520 Park East Blvd., New Albany, IN 47150 U.S.A **(812)-944-6733 / 1-800-SAMTEC9**	**Product Change Notification**

|	
1. ECR #: 169112 **Notification #:** 412	**2. Date of Announcement:** July 13, 2018

3. Series:
- TFM - .050 X .050 MICRO STRIPS

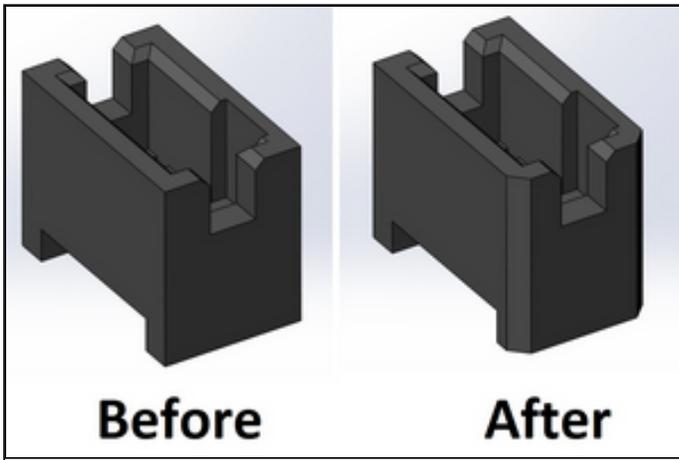
5. Description of Change:
Form change: Chamfers were added to the edge of the plastic insulator body to polarize orientation within tape & reel.

6. Method of Identifying Change
Visual: Chamfers are visible with unaided eye

8. Impact of Change on Form, Fit, or Function:
- Form - Added chamfers are visible under 10X magnification

7. Reason for Change:
This change is being made by Samtec to ensure parts are correctly oriented within tape and reel packaging. There is no change to fit or function of the finished good.
